Sample Reviewed Drawing Set

An AI pass over three sheets of a fictional municipal servicing set.

ROADWORKS AND WATERWORKS
"B" AVENUE EAST OF STREET 2
ADDRESS (TYP.)

SANITARY AND STORM SEWER
"B" AVENUE EAST OF STREET 2
ADDRESS (TYP.)

PAVEMENT MARKING AND SIGNAGE PLAN
ADDRESS

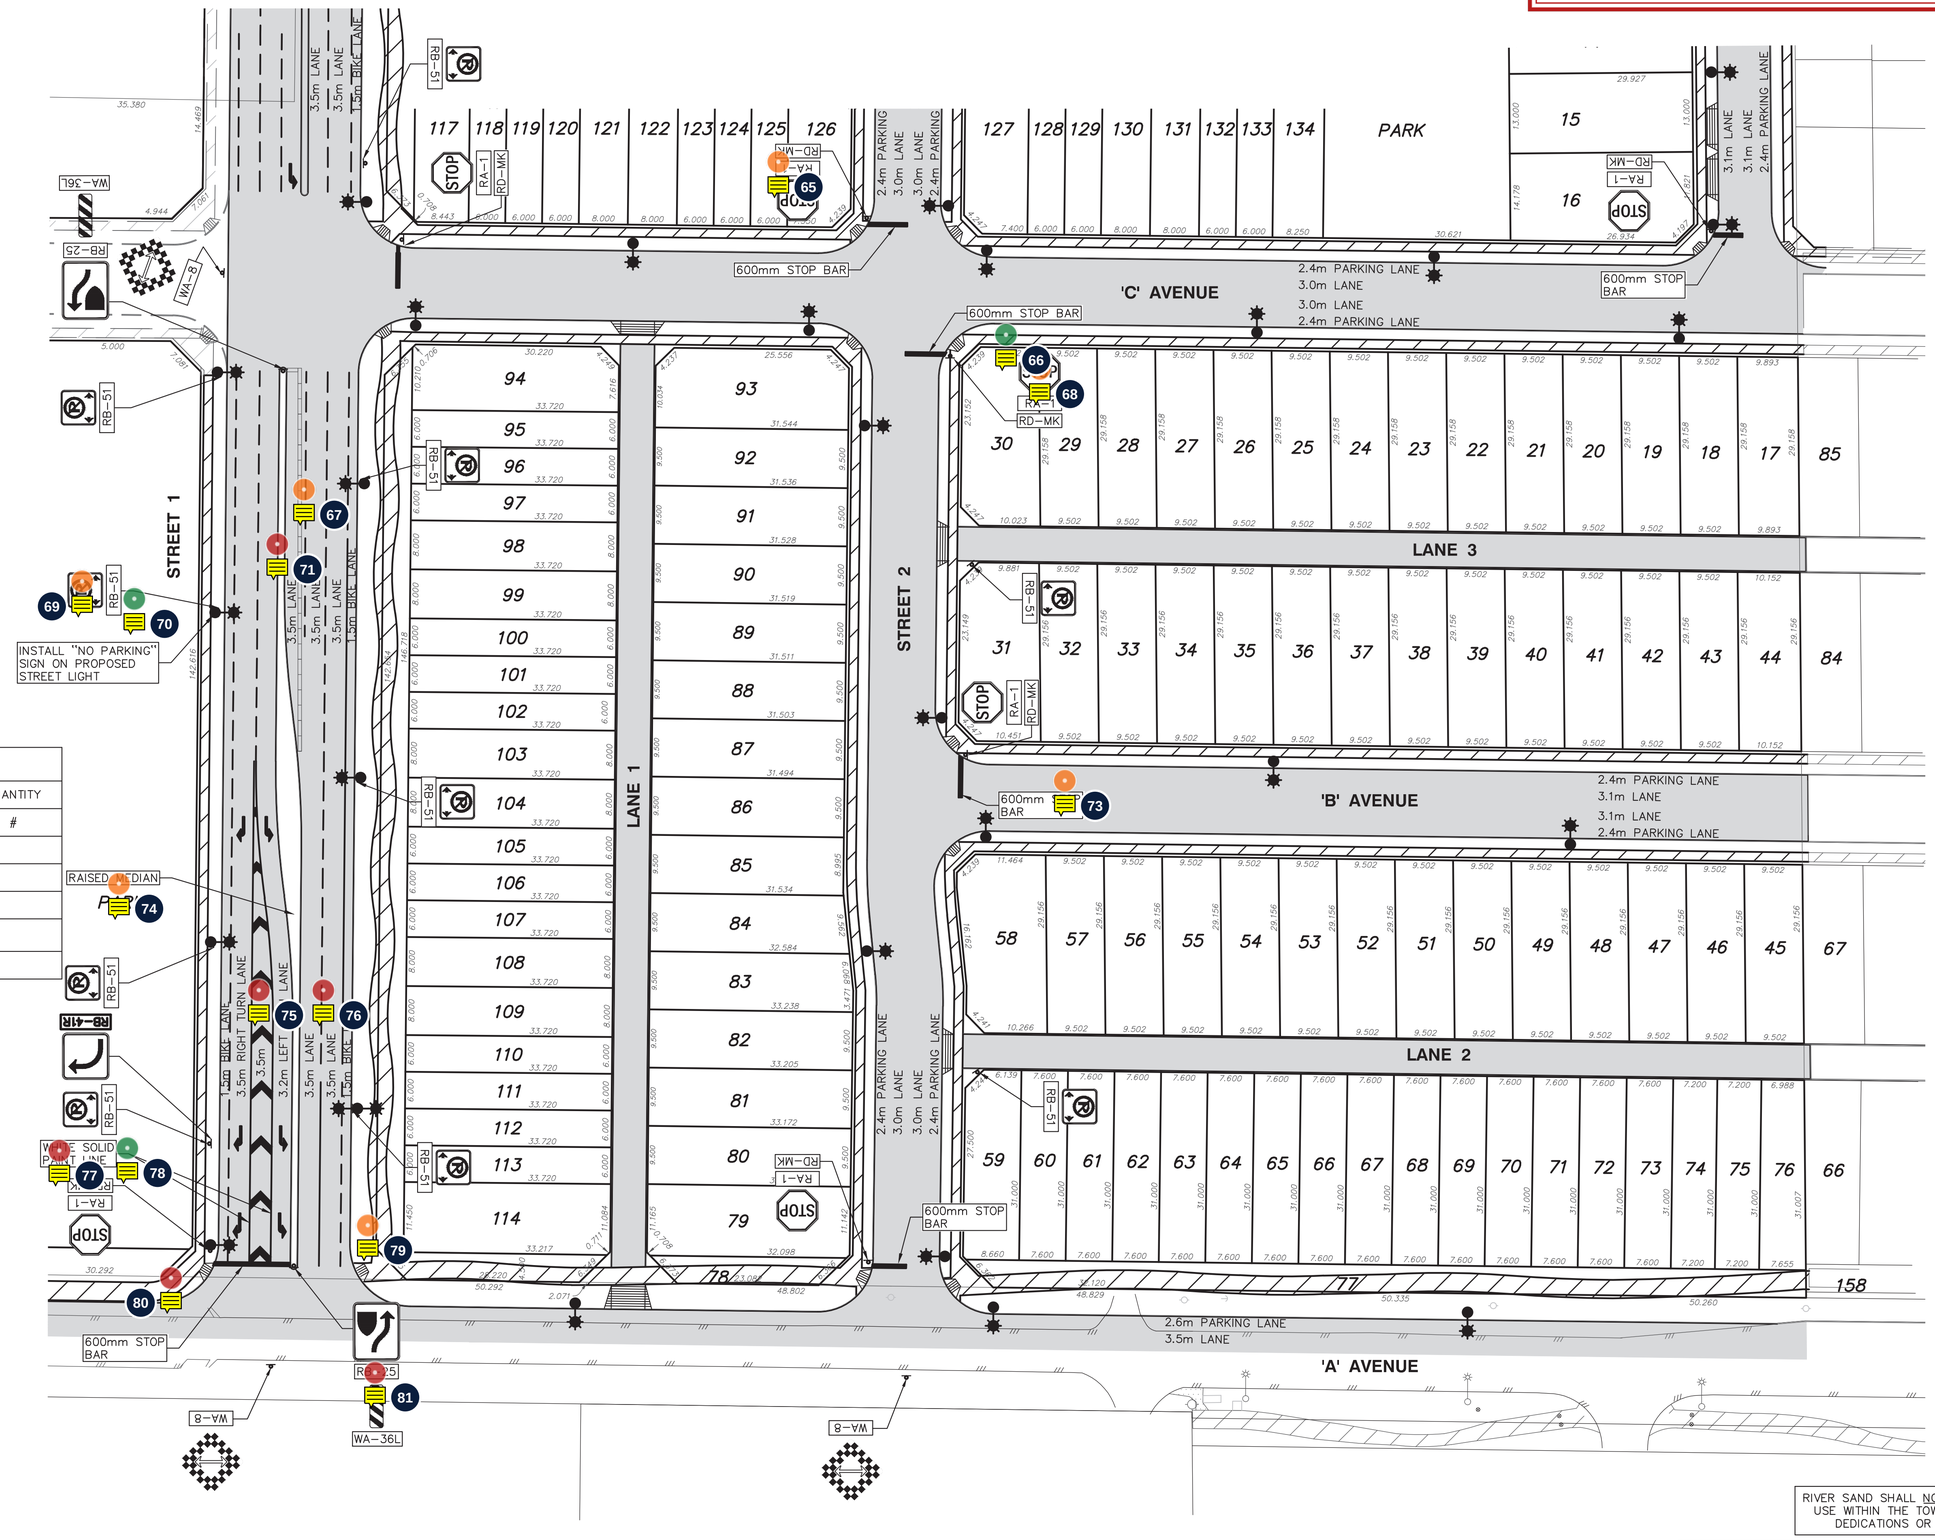
Finding: Stop bars on Street 2 and Lane 1 are aligned flush with curb returns without indicating the required setback. Section 8.9.1.8 requires motor vehicle stop bars to be set back 1.0m clear in advance of crosswalks, or 3.0m from curb returns where no crosswalks exist per Figure 8-4.

Finding: Dedicated turn bays on Street 1 (3.2m left-turn lane and 3.5m right-turn lane) omit turn arrow pavement markings. Section 8.9.1.5 requires turn arrows installed in thermoplastic conforming to Standard Detail Drawings R8.4 and R8.5.

Finding: The Sign Schedule table on the sheet is blank and unpopulated, with no sign types, MUTCD numbers, or quantities specified. Section 2.4.5.3 requires complete Sign Code Inventory tables detailing sign codes, quantities, and support types.

Finding: The title block and seal area contain placeholder text ('XYZ'), an unsigned and unsealed engineering certification block, an unpopulated revision table, and missing sheet numbers ('of XX'). Section 2.4.1.4 requires standard title blocks, completed revision blocks, and a valid BC Professional Engineer seal and signature.

Finding: The title block specifies a plan scale of HORIZ. 1:500. Table 2-4 in Section 2.4.1.5 requires Signage and Pavement Markings drawings to be prepared at a mandatory metric scale of 1:250 horizontal.

Finding: The pavement markings and signage plan is presented in black and white line work. Section 2.4.5.4 requires pavement marking plans to be submitted in colour, illustrating line additions, alterations, and eradications per MUTCD.

Action: Provide a minimum 6.0m statutory 'No Stopping' setback from property lines and crosswalks at intersections per Section 8.7.7.

Action: Add a general note or detail ensuring roadside signs are mounted with a minimum clearance of 2.1m to the bottom of the sign per Section 8.10.3.

Action: Provide thermoplastic turn arrows in the left-turn and right-turn bays on Street 1 in accordance with Section 8.9.1.5 and Standard Detail Drawing R8.4.

Action: Review pedestrian connectivity and provide standard zebra crosswalk markings per Section 8.9.1.7 where pedestrian crossings are established.

Action: Apply bicycle green surface treatment and 300mm x 300mm elephant's feet crossbike markings across intersection conflict zones per Section 8.9.1.12 and Drawing R8.9.

Action: Revise stop bar marking widths from 600mm to 0.3m (300mm) solid white lines per Section 8.9.1.8 and Section 8.9.1.1.

Action: Replace WA-36L markers with WA-36R (slanted down to the right) for pass-on-right median approach noses per Section 8.10.3.2.

Action: Provide explicit references to City Survey Control Monuments, horizontal datum NAD83(CSRS), and vertical datum CGVD28 in the benchmark block per Section 2.4.1.6.

Action: Complete the title block with actual project personnel, revision history, sheet numbers, and have the drawing signed and sealed by a BC Professional Engineer per Section 2.4.1.4.

Action: Rescale the signage and pavement markings plan to 1:250 horizontal scale with graphic bar scale per Section 2.4.1.5 and Table 2-4.

Action: Submit pavement marking plans in full colour with distinct line color tones per Section 2.4.5.4 and Section 2.4.1.8.
